**Idaho
National
Engineering
Laboratory**

**TECHNICAL EVALUATION REPORT
WESTINGHOUSE CODE
QUALIFICATION DOCUMENT FOR
BEST ESTIMATE LOSS OF COOLANT
ACCIDENT ANALYSIS, WCAP-12945-P**

INEL-95/0608

Prepared for the
U.S. Nuclear Regulatory Commission
Washington D.C. 20555
Under DOE Contract No. DE-AC07-94ID13223
JCN L1696, Task Order 7, TAC No. M81712

FIGURE 1 BREAKDOWN OF WESTINGHOUSE'S UNCERTAINTY PARAMETERS

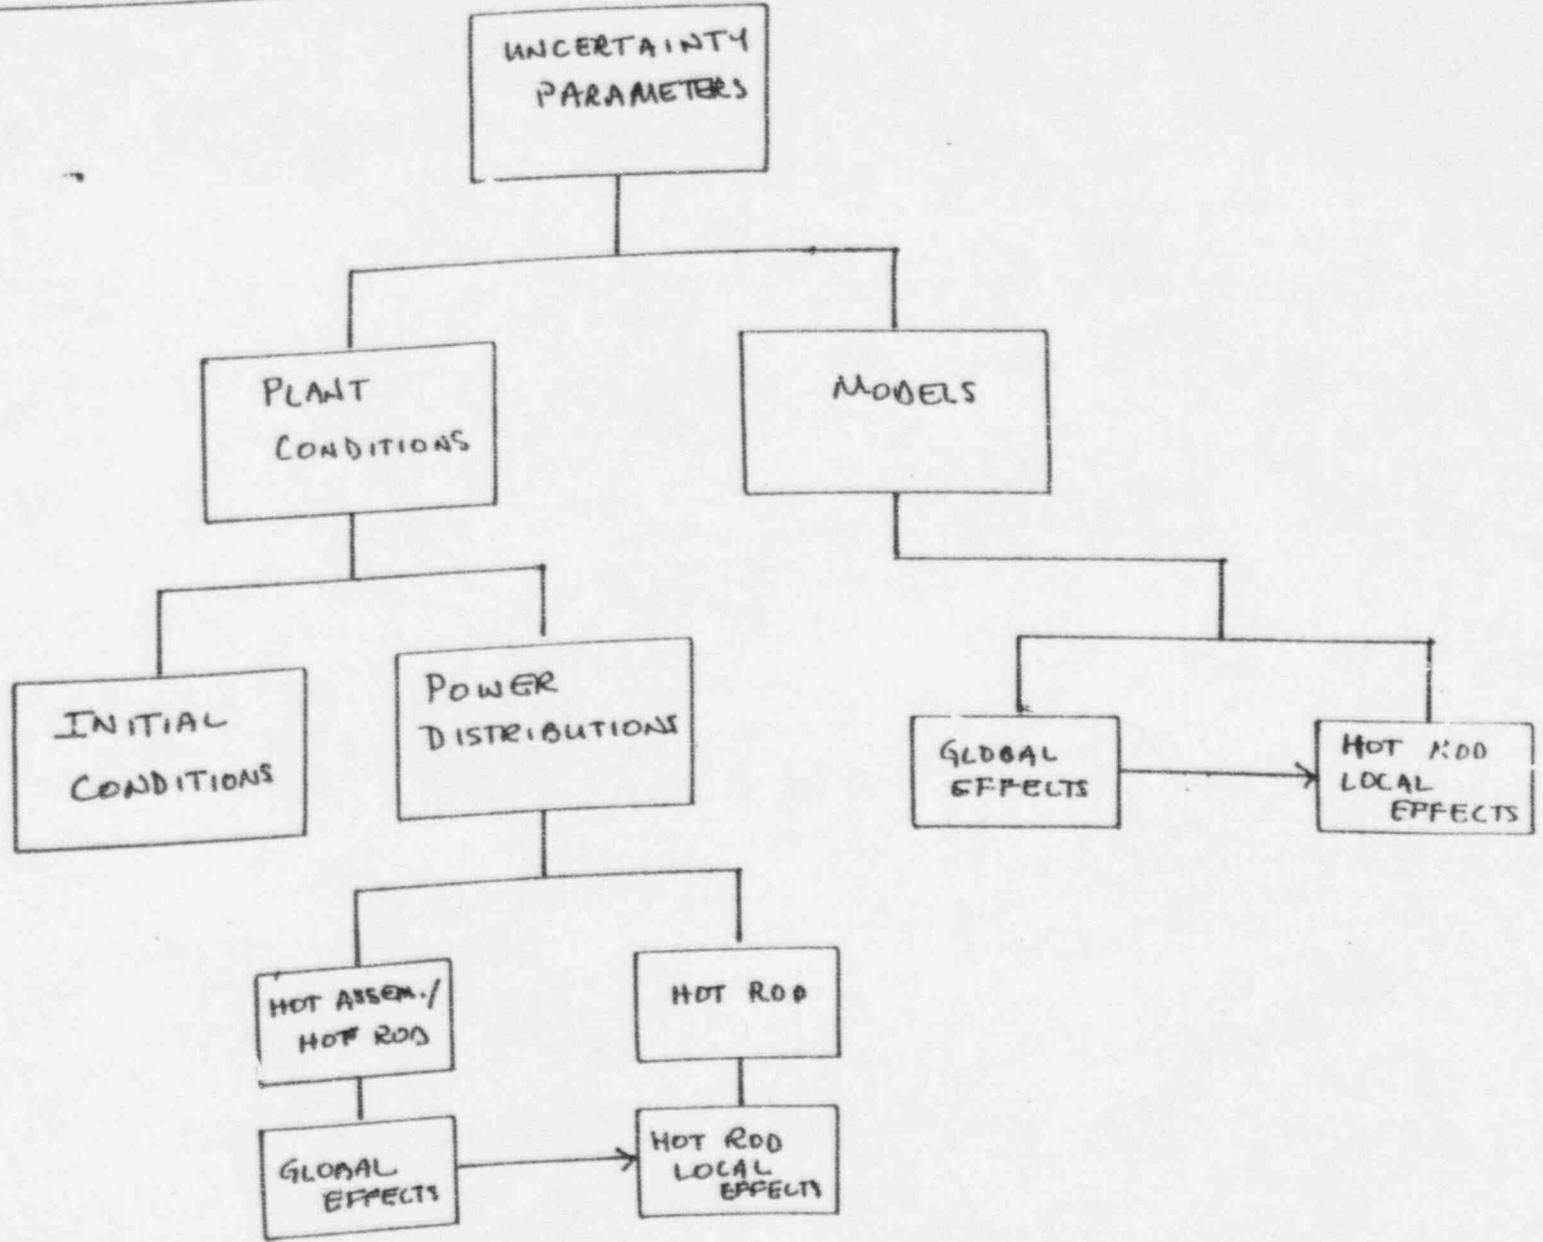
Westinghouse's uncertainty analysis is divided into several parts. First, code models and initial plant condition parameters are ranged to determine their uncertainties and the effects of those uncertainties on PWR calculations (call this Part A). Part A is subdivided into global plant conditions (initial conditions and power distributions), global models (code models whose uncertainty is accounted for directly), and local effects at the PCT hot spot. This division is illustrated in Figure 1.

FIGURE 2. FLOWCHART OF UNCERTAINTY DETERMINATION PROCEDURE

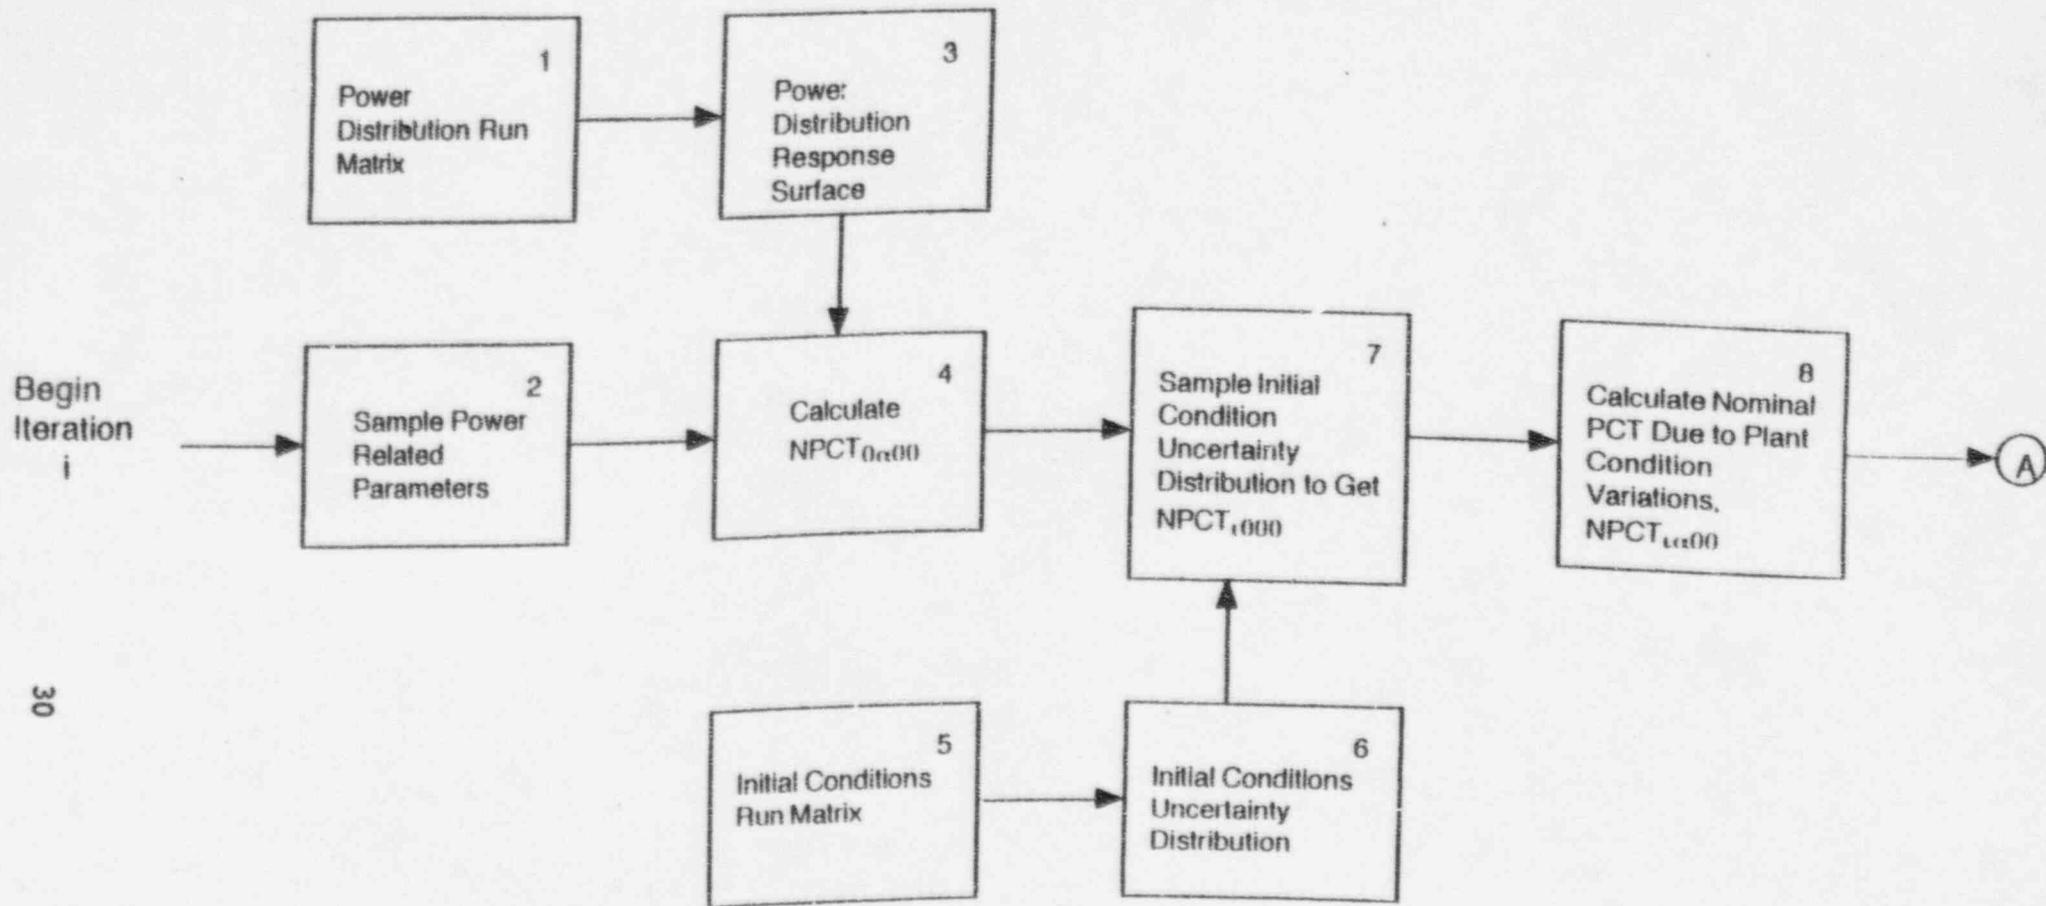
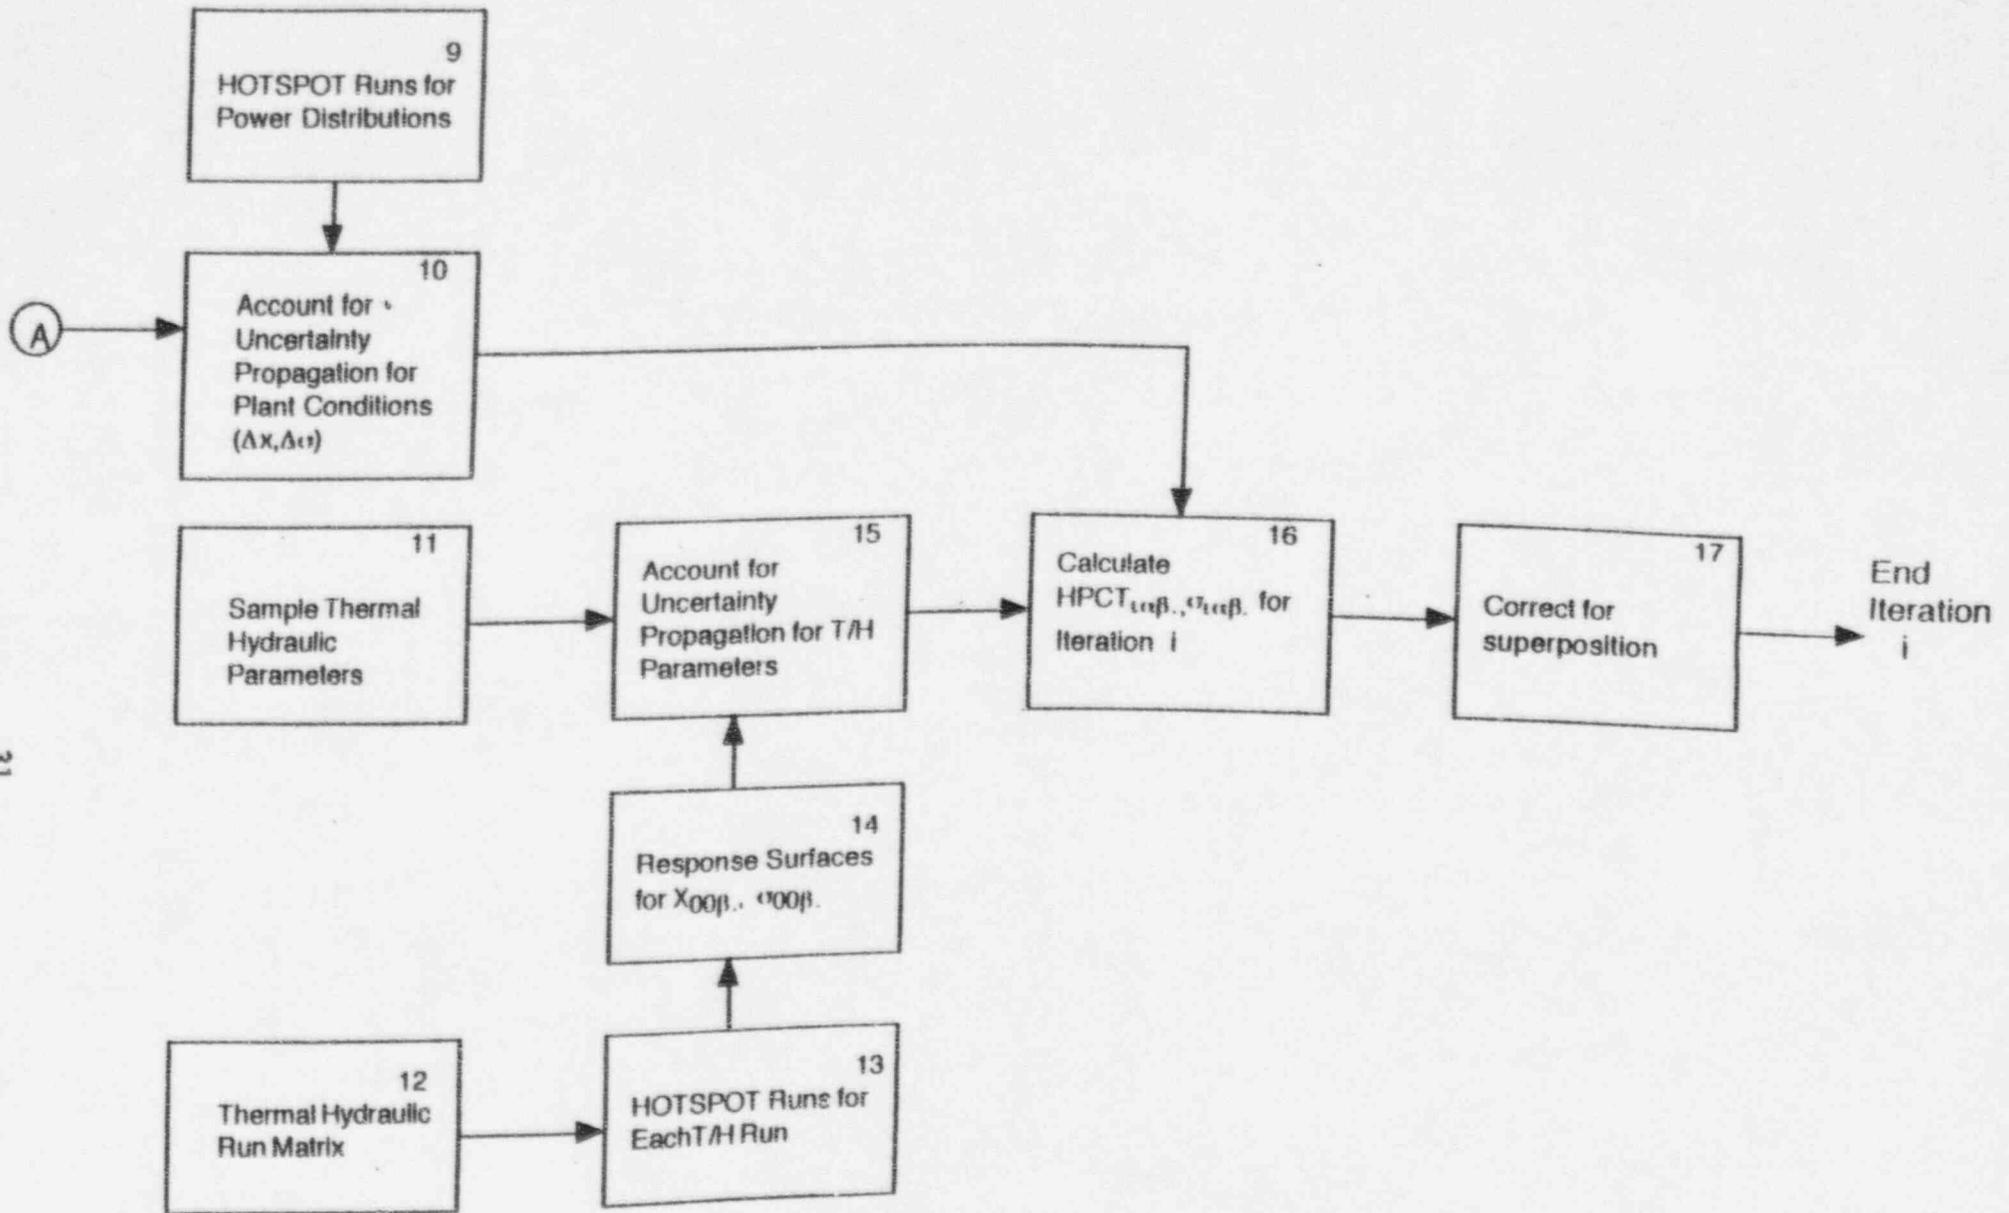
The Westinghouse realistic LBLOCA methodology consists of several parts. To determine the 95th percentile PCT, Westinghouse uses the WCOBRA/TRAC code and then performs an uncertainty analysis. The WCOBRA/TRAC base code is described briefly in Section 9.1 of this report and in more detail in Appendix A of this report. Then there is the analysis to determine the 95th percentile PCT. This analysis is discussed in Sections 6.2 and following of this report. Westinghouse's use of WCOBRA/TRAC is described first followed by the 95th percentile PCT determination. Figure 2 summarizes the steps.
